Zoning & Subdivision Committee	2
Thursday, February 13, 2014 12:15 pm	۱

Staff Report – Jerome Village Preliminary Plat Extension

COUNTY OF UNION, OHIO PRELIMINARY PLAT FOR	Date January 3, 2008	Job No. 2006-1643
FACE SHEET	Scale As Noted	Sheet 1/27
	Como	ress

Job No. January 3, 2008 2006-1643 Sheet 24/27 1"=400'

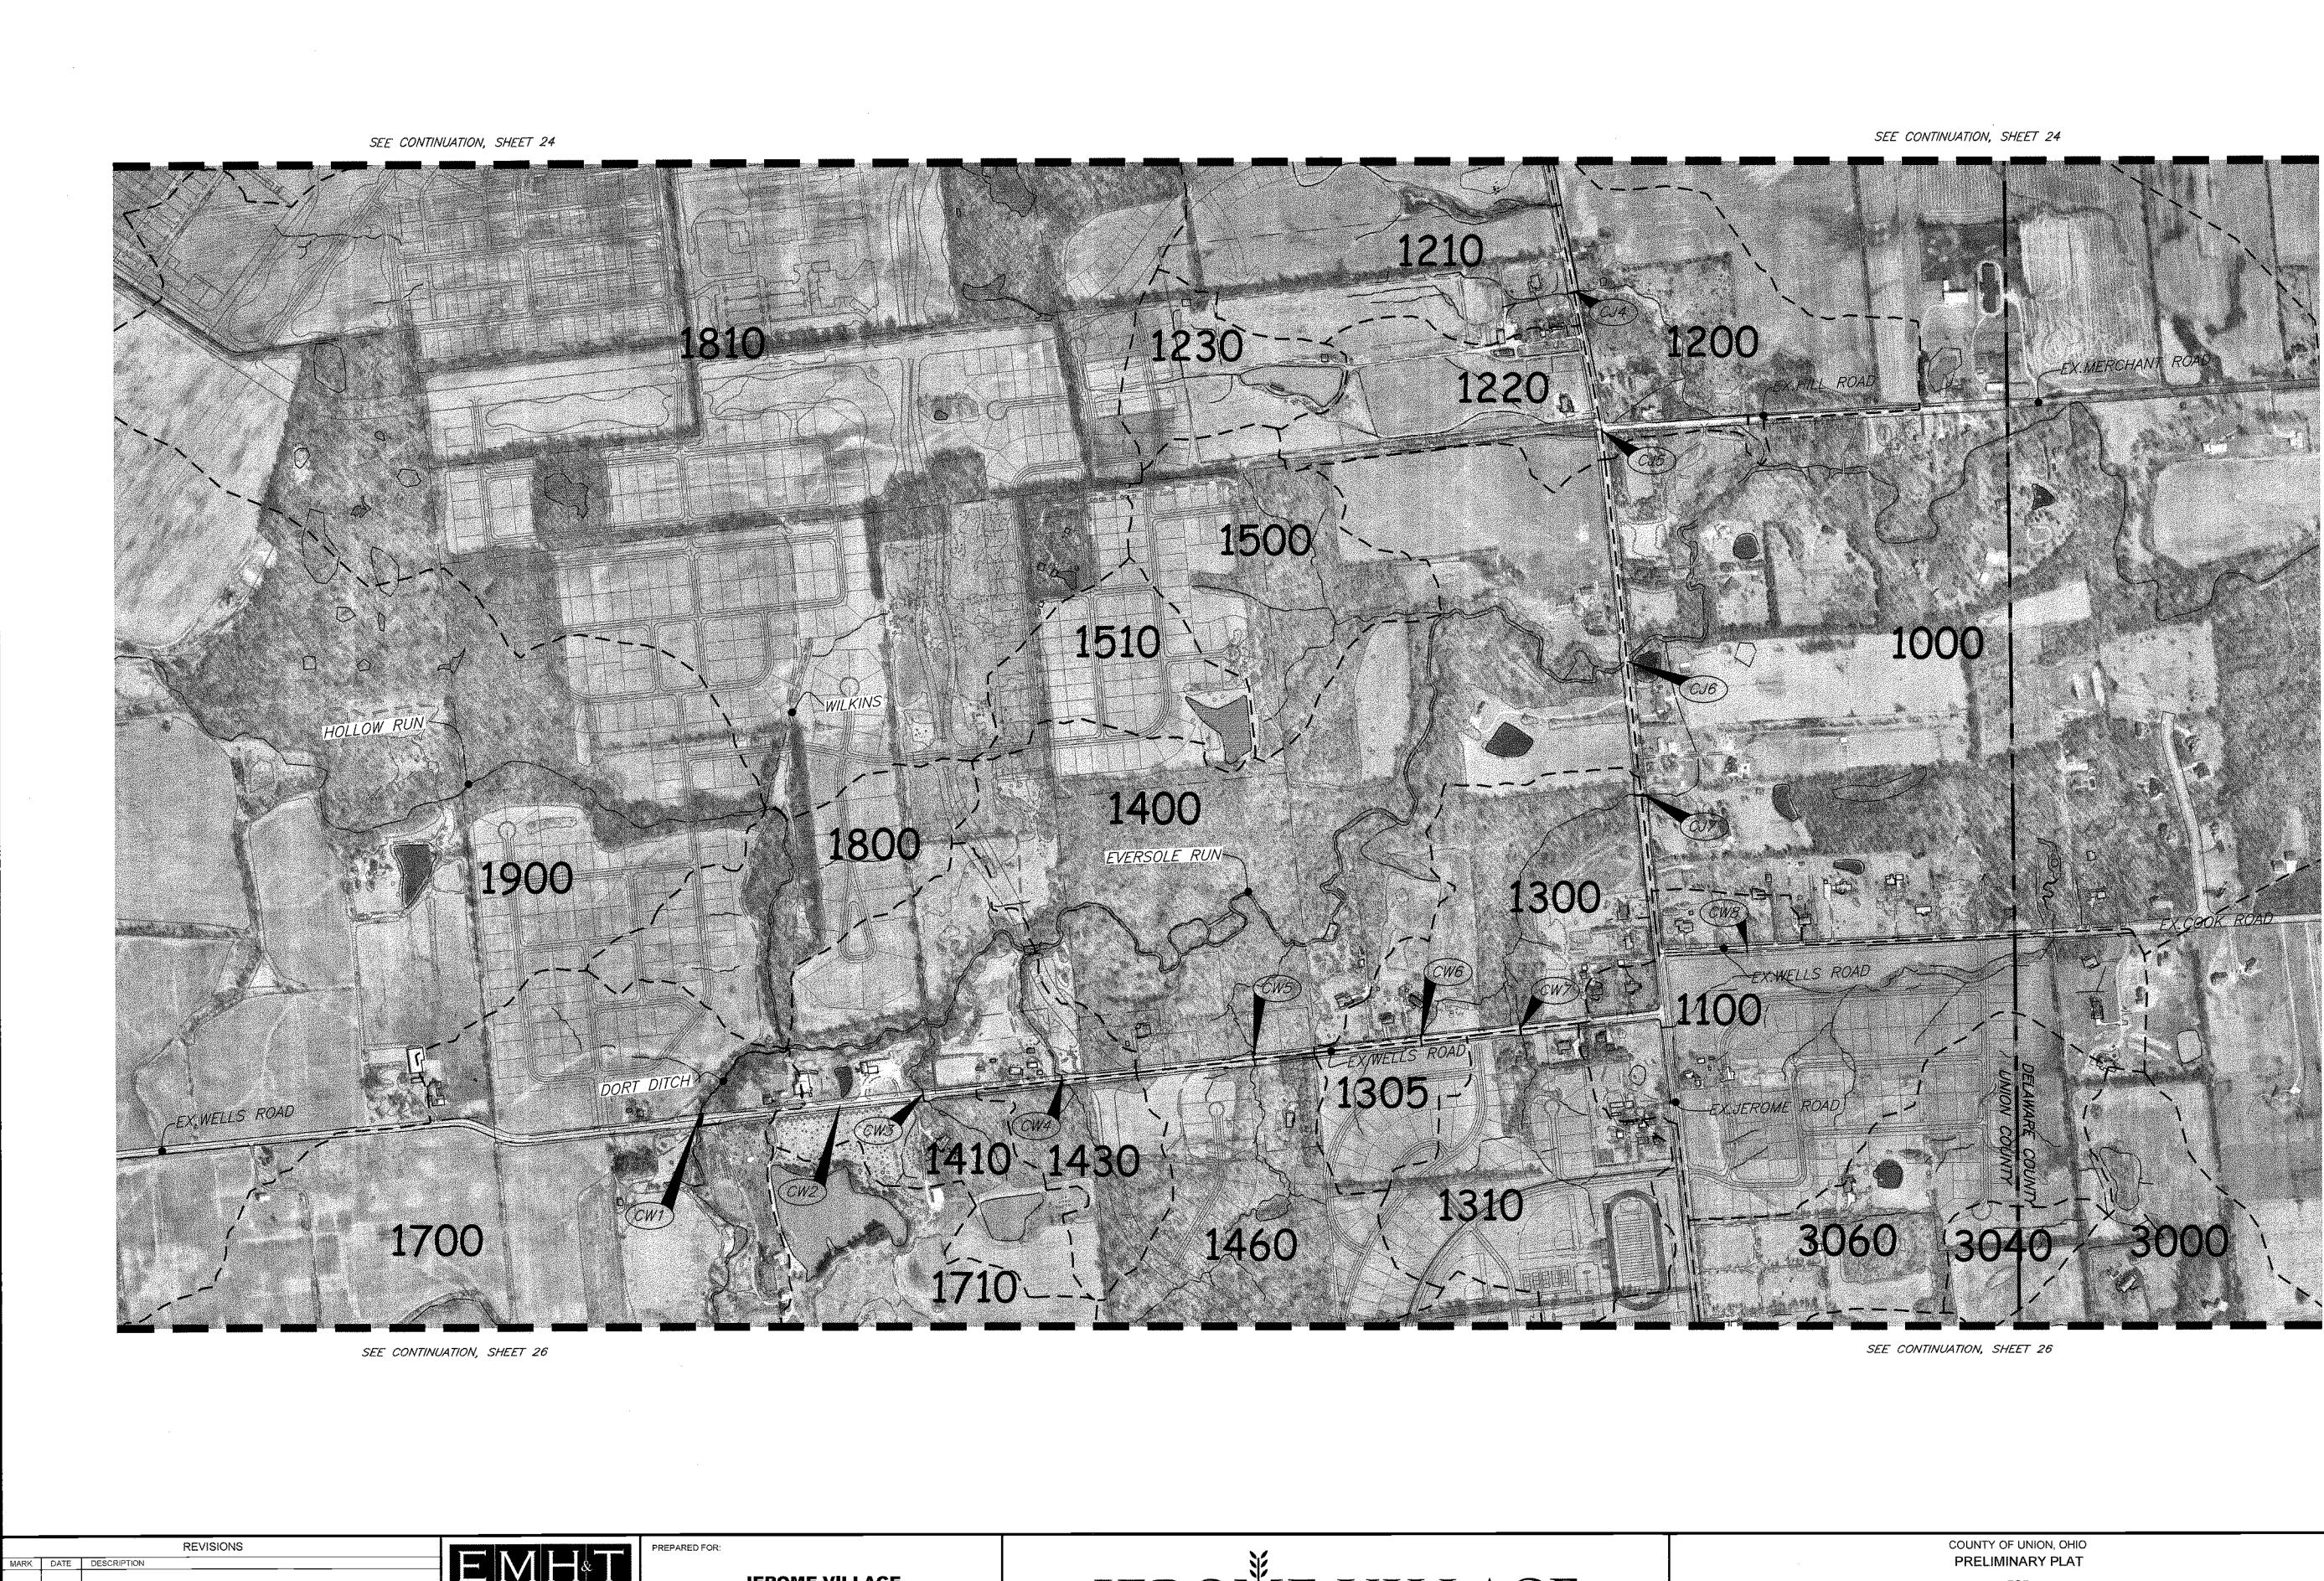
- 16. Stormwater calculations performed for each subarea/pod shall use the watershed characteristics identified in the Preliminary Plat.
- 17. Add Union County Standard Deed Restrictions:
